THE PORT AUTHORITY OF NY & NJ
PROCUREMENT DEPARTMENT
4 WORLD TRADE CENTER
150 GREENWICH STREET, 21ST FL.
NEW YORK, NY 10007

ADDENDUM # 6

To prospective Proposer(s) on RFP # 52308 – Solar “Carport” Photovoltaic (PV) Power Generating System at the Port Authority of New York & New Jersey’s Stewart International Airport:

EXHIBIT 2B – MAIN TERMINAL ELECTRIC ONE-LINE DIAGRAM:

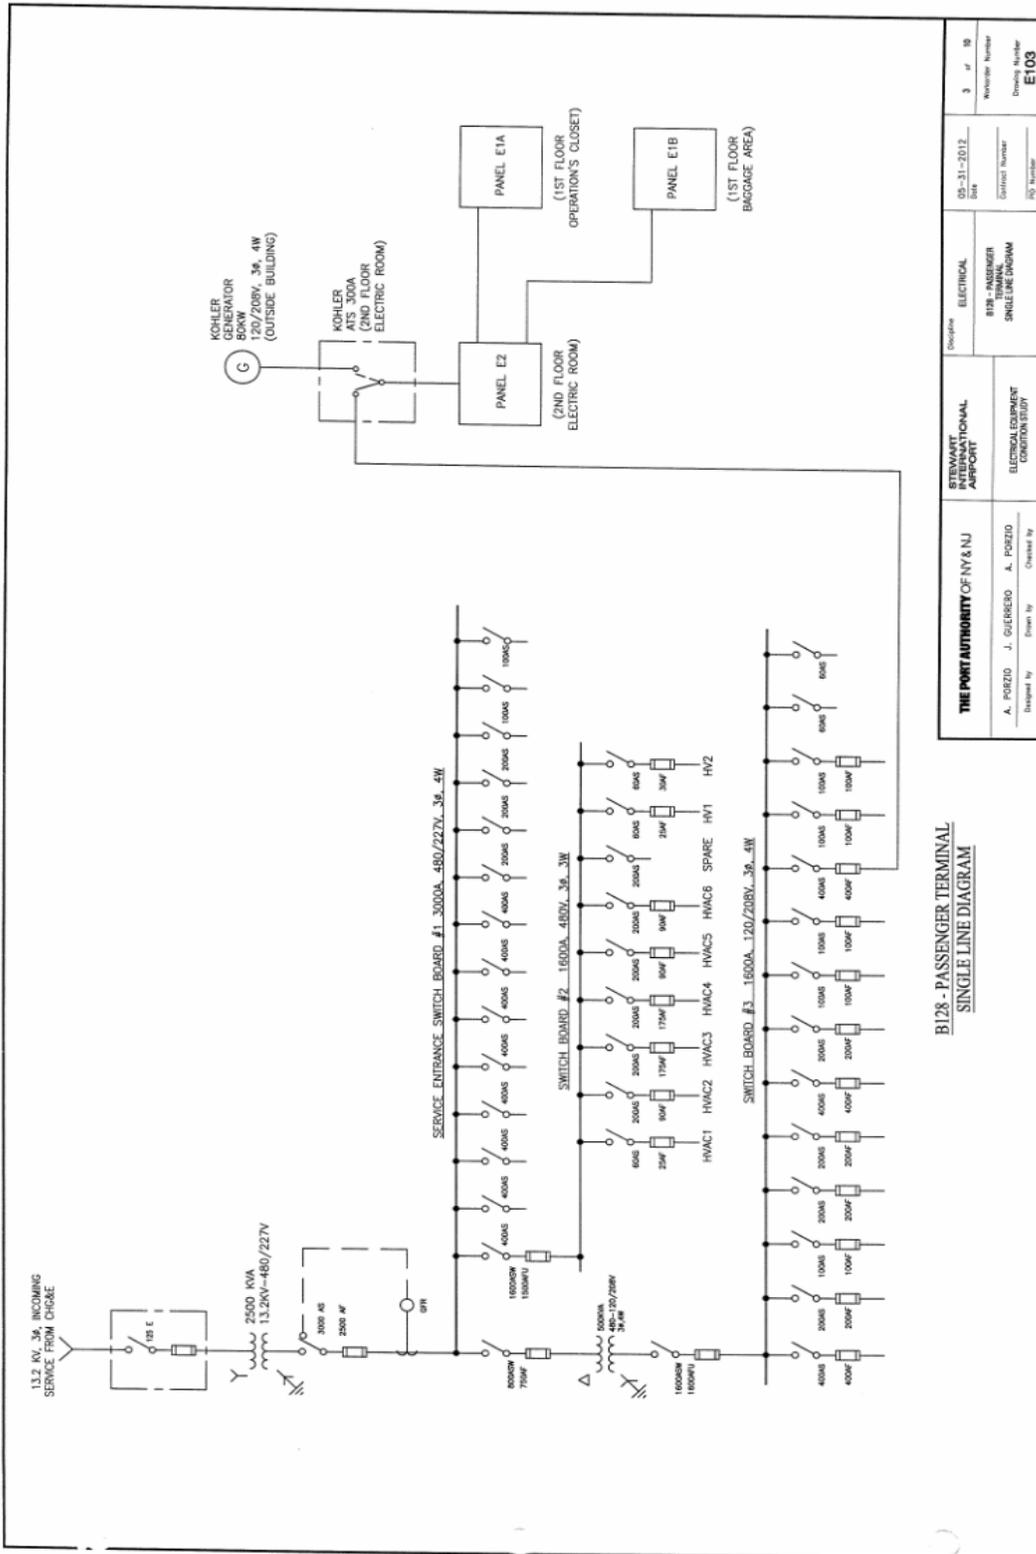
Q9. We request to receive the following existing condition drawings: Electrical single line

- Q24. If a site visit cannot be arranged, can the facility provide a single-line diagram as well as detailed pictures of the electrical room and clear pictures of the nameplates on the MDP?

A9. The electric one-line diagram for the main terminal is attached as Exhibit 2B attached to the RFP (see above Changes/Modifications, item C).

- A24. A one-line diagram has been provided as Exhibit 2B attached to this Addendum.
- Q25. Can the facility provide us with a designated equipment staging area as well as an area for temporary construction parking?

EXHIBIT 2D – SUBSURFACE CONDITIONS REPORT
 Sheet 1 of 3

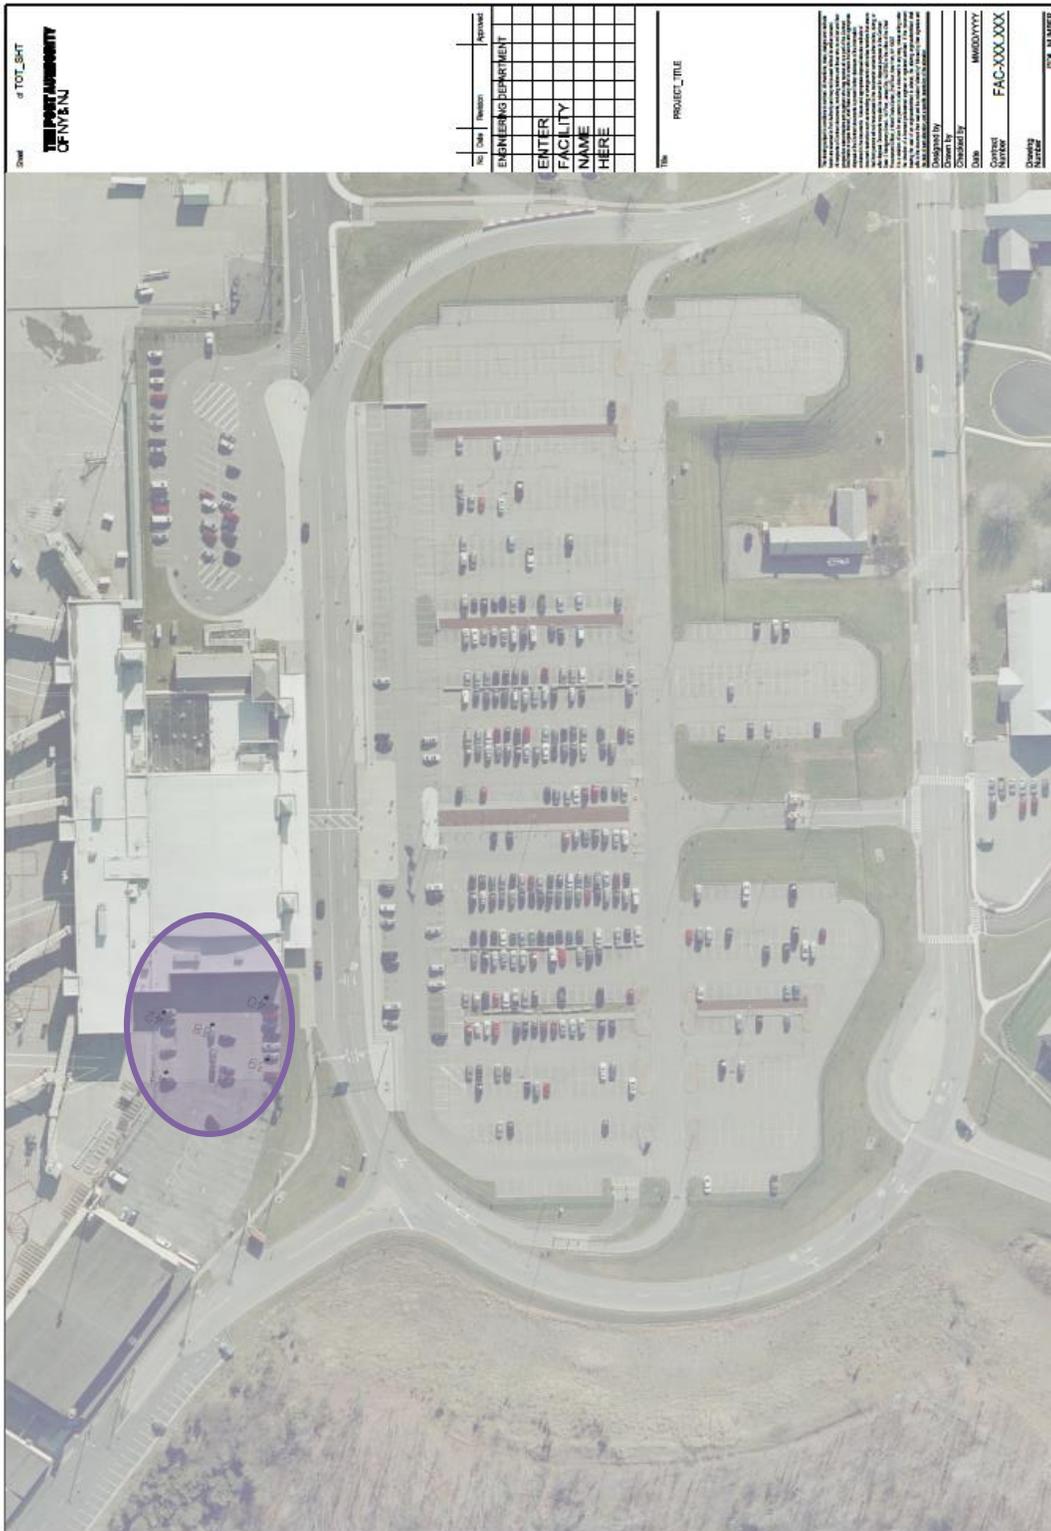
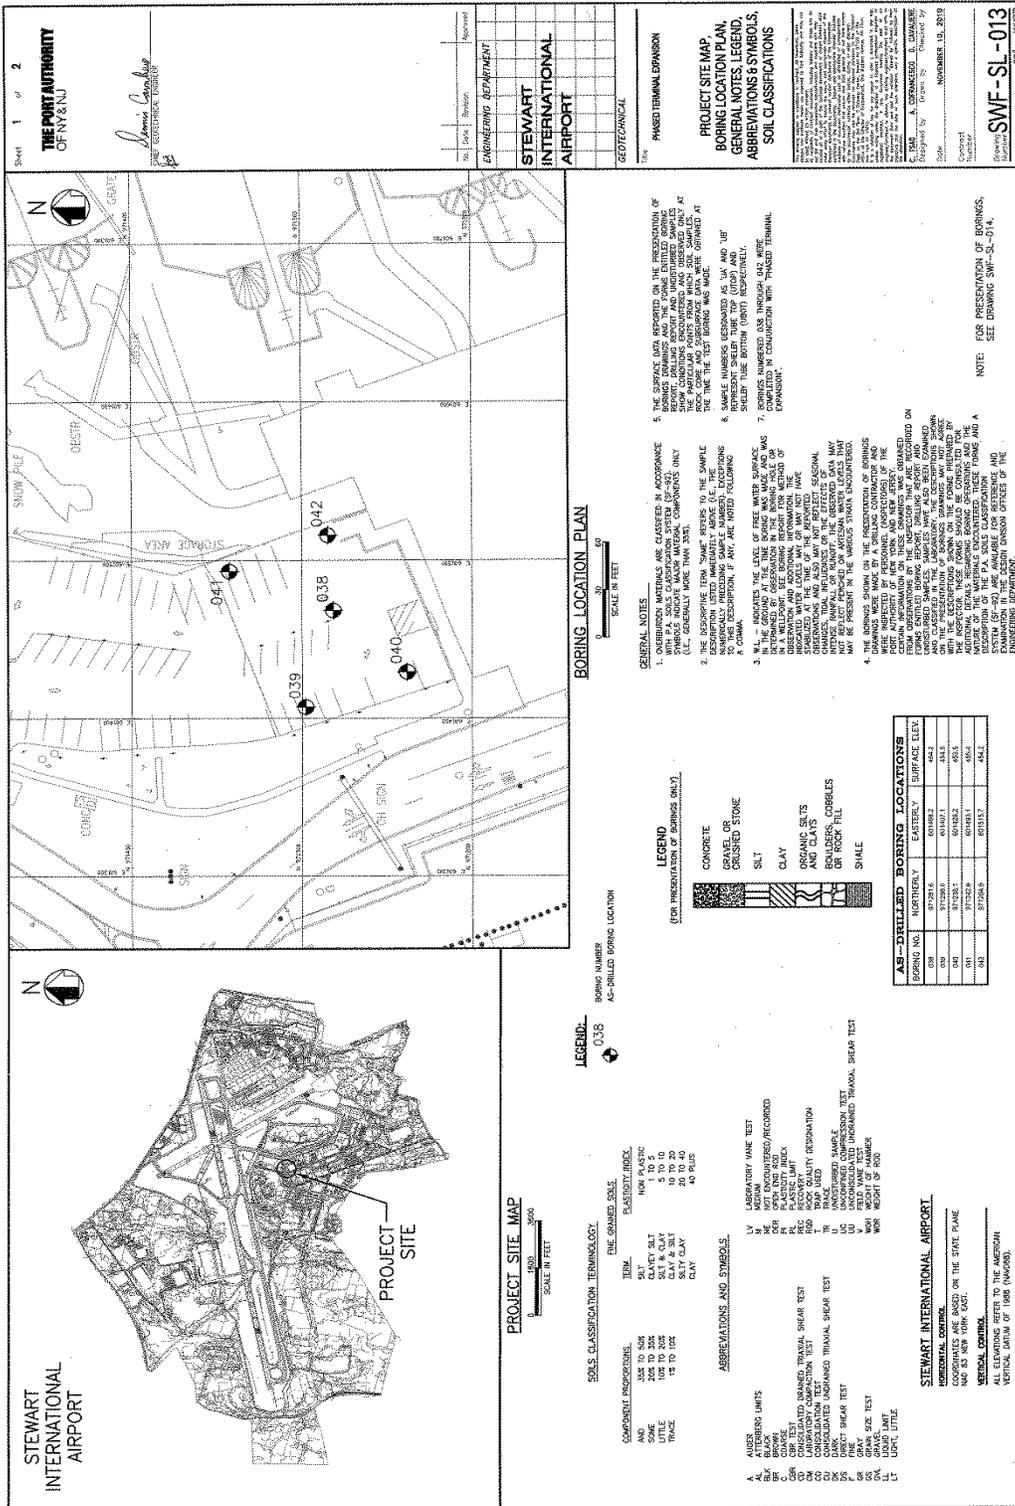
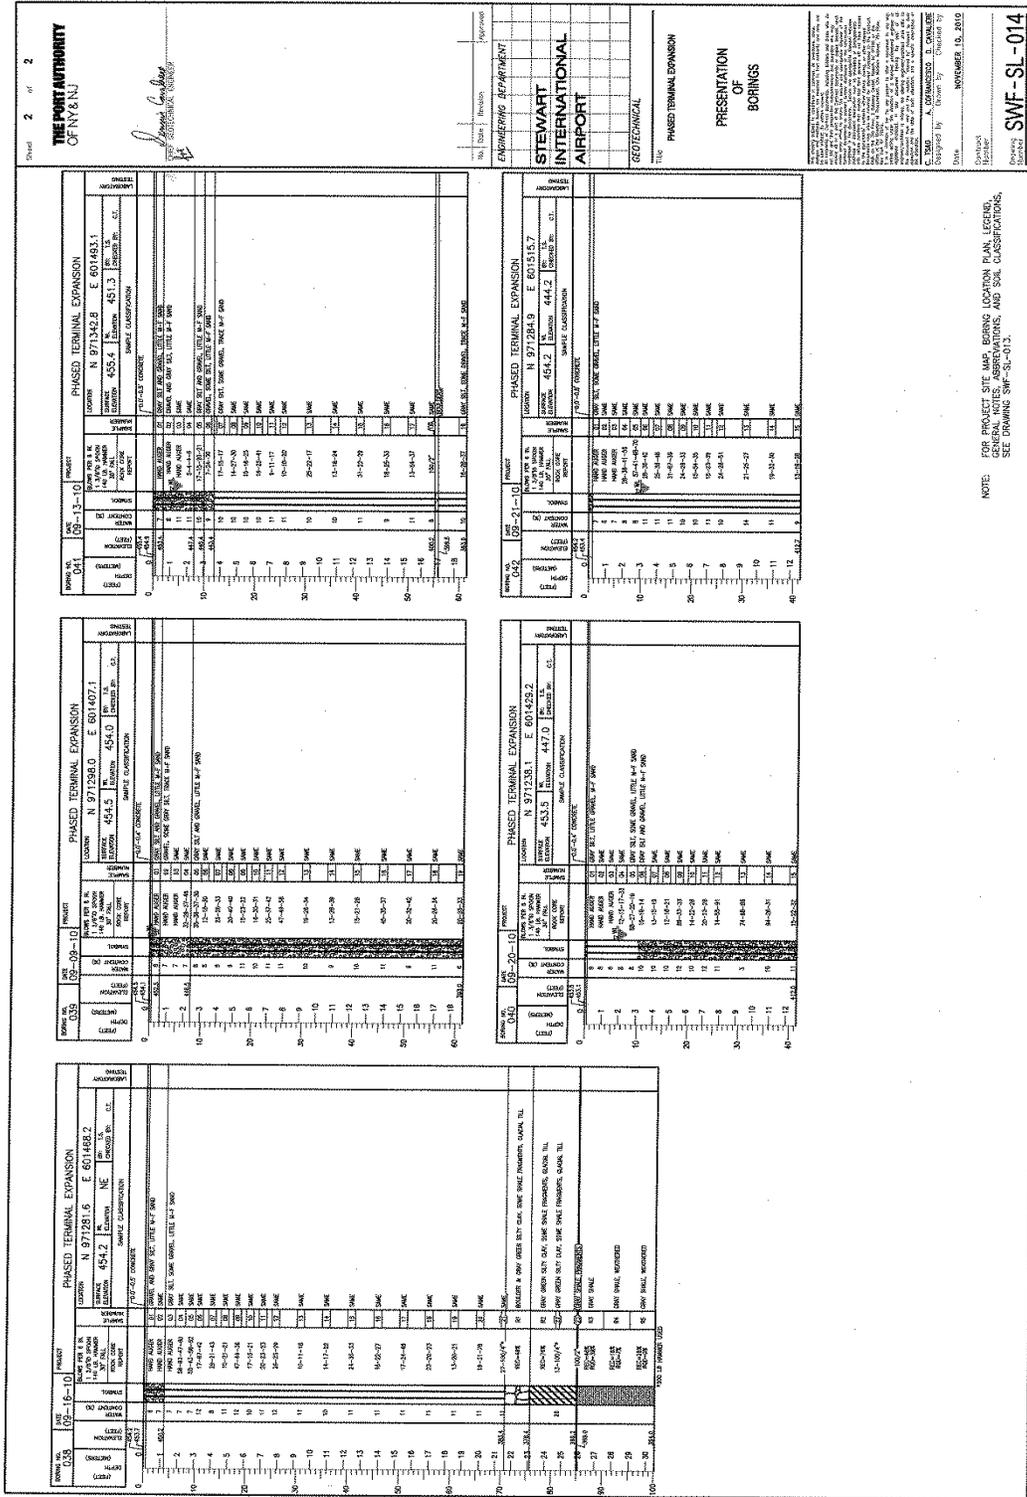
Q10. We request to receive information that is available related to existing Water Management and Soil Conditions.

A10. A subsurface conditions report is attached as Exhibit 2D (see above Changes/Modifications, item C).
